## **CONSTRUCTABILITY REVIEW OF EPA PREFERRED TECHNOLOGY AREAS**

This memorandum presents a technical discussion and a summary of potential constructability issues associated with the U.S. Environmental Protection Agency's (EPA's) Preferred Technology Screening and Assignments, as presented to the Lower Willamette Group (LWG) on April 24, 2014. Figures 1a through 1d present the EPA Preferred Technology Screening Areas overlain with draft Feasibility Study (FS) subSMAs for a selected set of Sediment Management Areas (SMAs). This memorandum indicates potential issues and suggested changes to EPA's technology assignment approach that are in addition to suggestions to the technology assignment criteria and scoring methodologies provided in the LWG's May 2, 2014 submittal to EPA on this subject.

Figure 1b  
**Portland Harbor RI/FS**  
Draft Feasibility Study  
EPA Preferred Technology Analysis - SMA 13

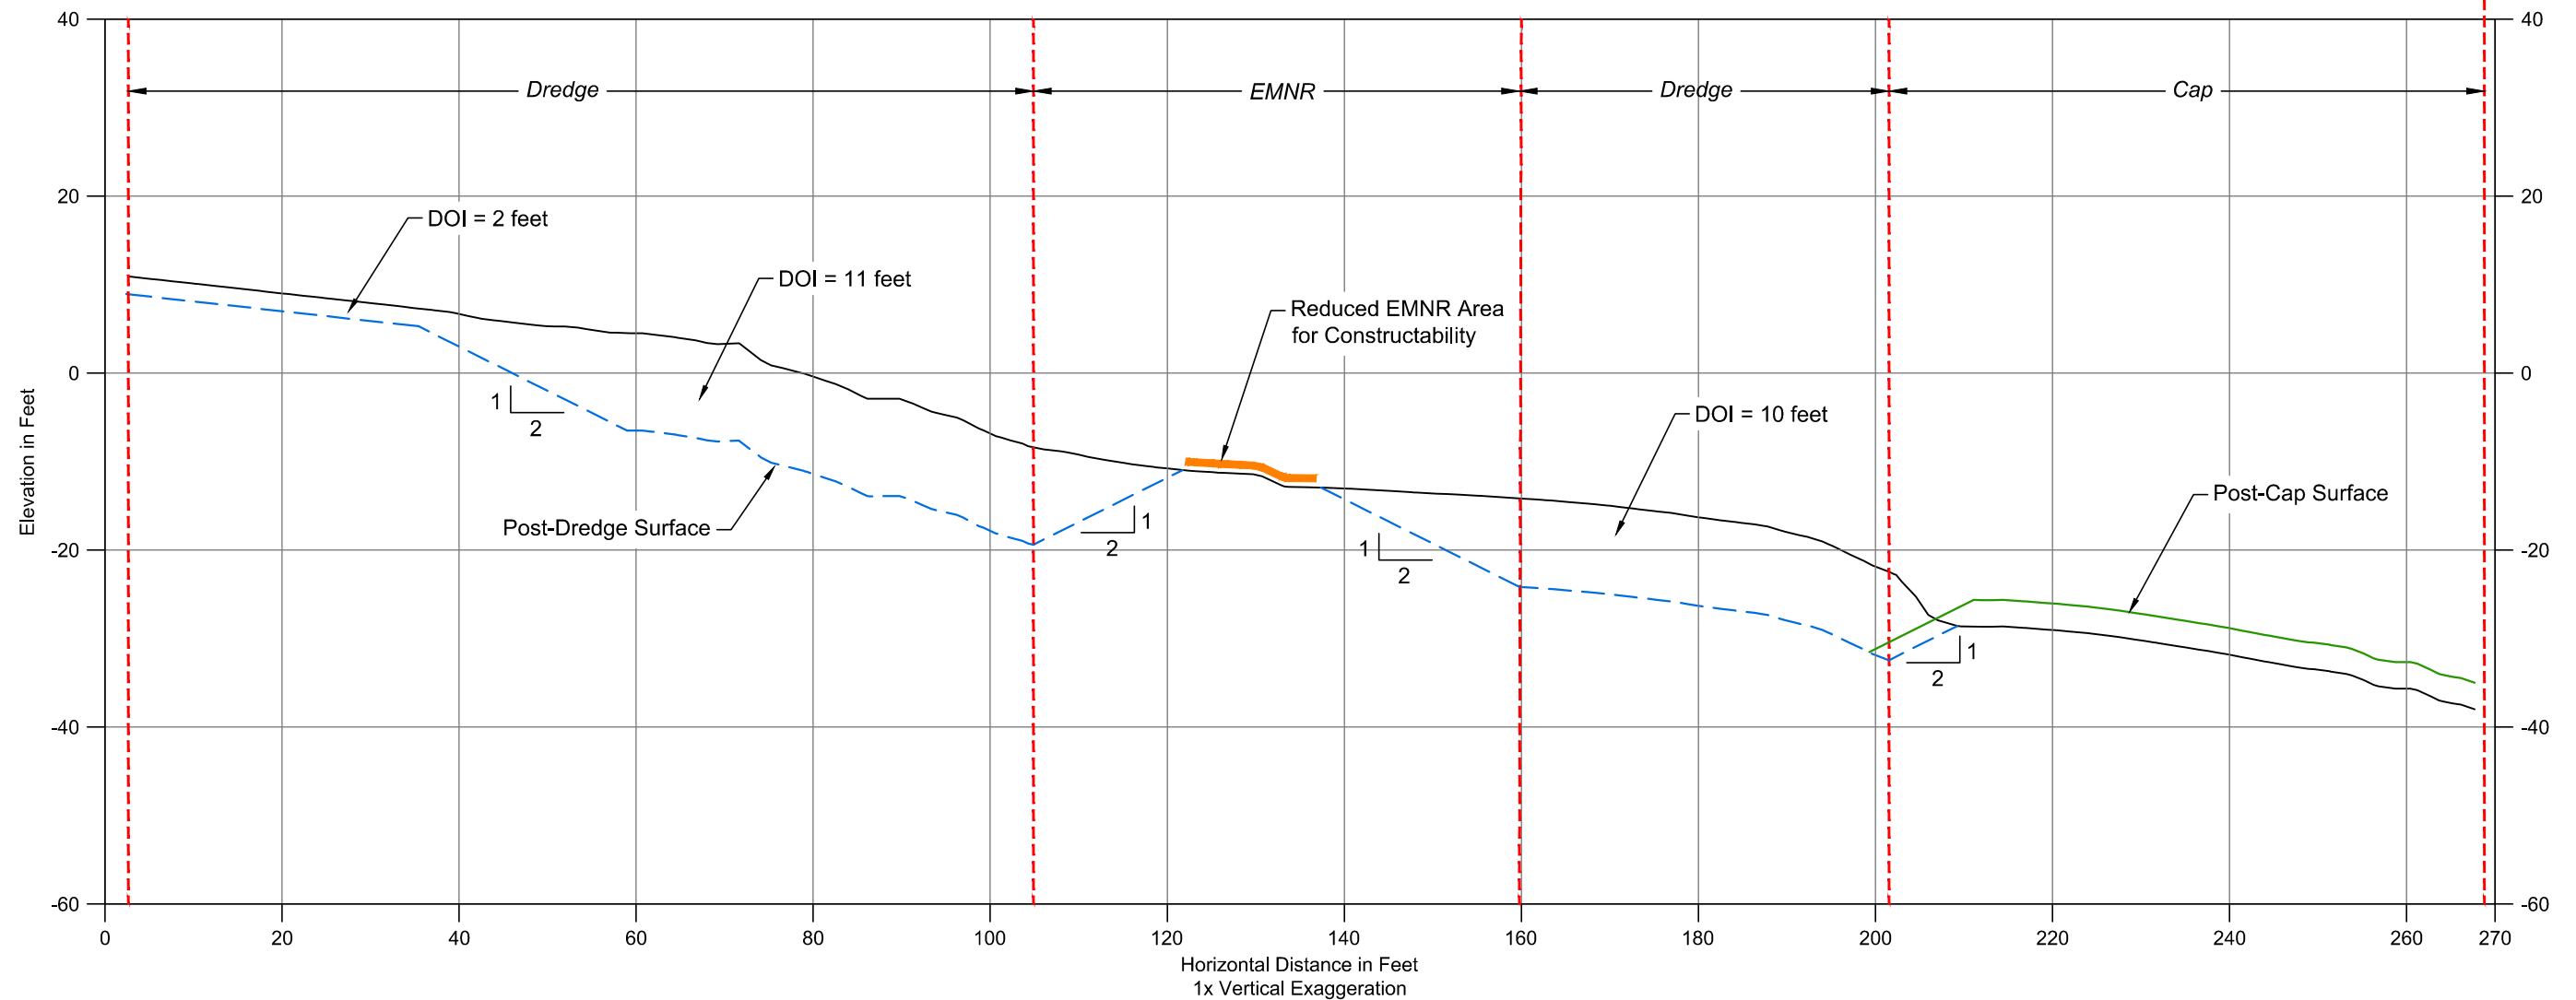
Figure 1b presents a focused view of the EPA’s technology assignments for SMA 13 and notes for areas that present examples of constructability concerns. Potential constructability issues are discussed in detail as follows.

- **Note 5—Dredge Slopes and Cap/EMNR Areas**—This area has similar constructability concerns as discussed in Note 3 and 4. Because the DOI in this area is 2 feet and the slope in this area is approximately 4H:1V, the dredge slope daylights approximately 10 feet upslope of the dredge area. This would likely prevent any combination of EMNR/Capping and dredging across this slope.
